WEST SUSSEX COUNTY COUNCIL CONSULTATION

TO:	Arun District Council FAO: Maria Tomalova
FROM:	Highways, WSCC
DATE:	04/09/2020
LOCATION:	41-47 Pevensey Road, Bognor Regis, PO21 5NY
SUBJECT:	BR/188/20/DOC Approval of details reserved by condition imposed under ref APP/C3810/W/19/3230749 (BR/229/17/PL relating to Condition Nos 5 - surface water drainage, 6 - discharge flows to watercourses, 8 - materials & finishes, 9 - landscaping, 10 - boundary treatments, 11 - refuse/waste storage space/collection, 12 - pedestrian visibility splays, 14 - covered & secure cycle parking and 15 - electric vehicle charging.
DATE OF SITE VISIT:	N/A
RECOMMENDATION:	Advice, More Information
S106 CONTRIBUTION TOTAL:	£N/A

Condition 12 – Pedestrian Visibility Splays

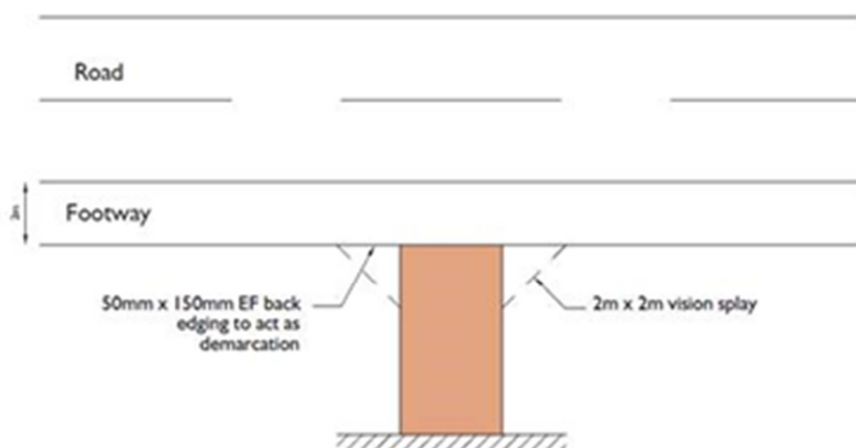
The applicant has demonstrated pedestrian visibility splays for the proposed access. However, these have not been drawn to standard. For pedestrian visibility, there should be splays between a driver's viewpoint 2m back into the access and a distance measured along the back of the footway for 2m on each side of the viewpoint. The below diagram shows a dropped kerb style crossing with a clear 2m by 2m area either side for pedestrian visibility.

Please request the applicant to have these redrawn to this standard.
